**Addendum to the
Berth 240 Transportation Vessels Manufacturing
Facility Project
Final Initial Study and Mitigated Negative
Declaration**
APP No. 170117-008

February 2020

3. Proposed Revised Project

DUDEK SOURCE: Mulder & Katkov Architecture (2017) **FIGURE 2.4-1**
Proposed Project Site Plan
Transportation Vessels Manufacturing Facility Project Draft IS/MND

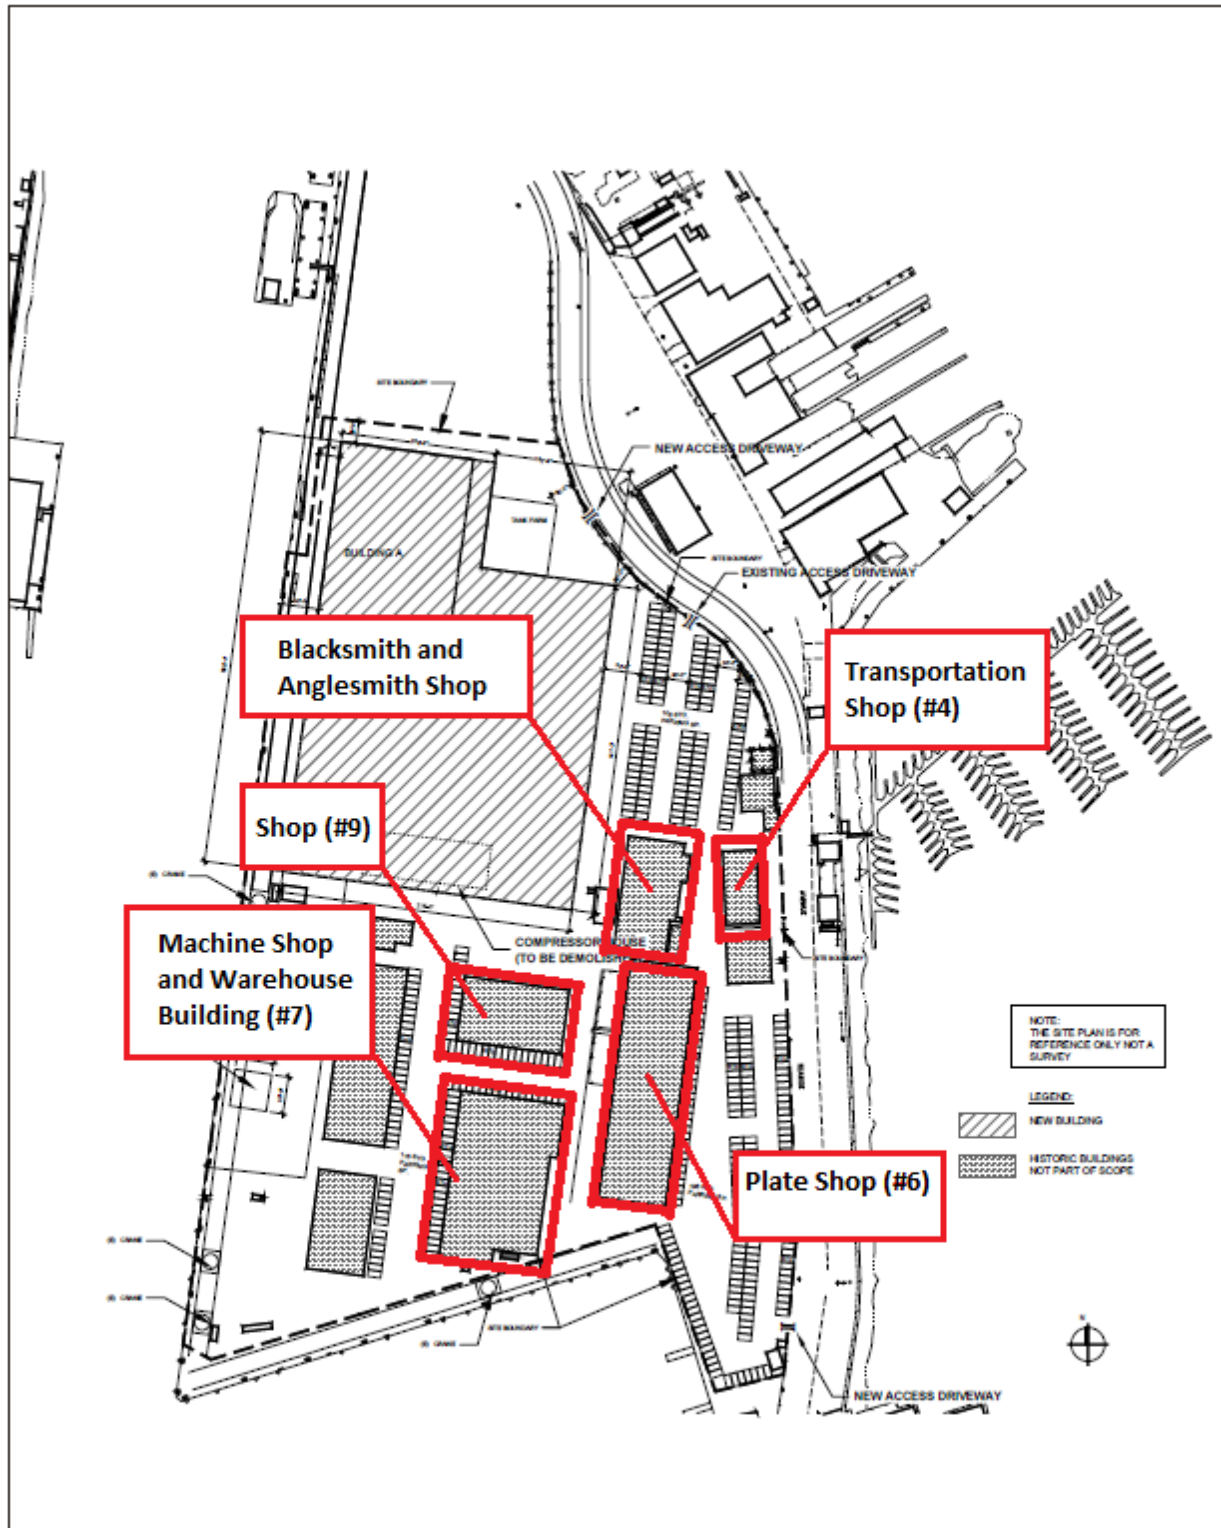
Furthermore, any modifications to the buildings identified in Figure 2.4-1 would follow the standards adopted by the Secretary of the Interior in Standards for the Treatment of Historic Properties in accordance with LM CUL-1 and require written approval by the Harbor Department. Therefore, the Proposed Revised Project would not cause any change in impact determination from the 2018 Final IS/MND.
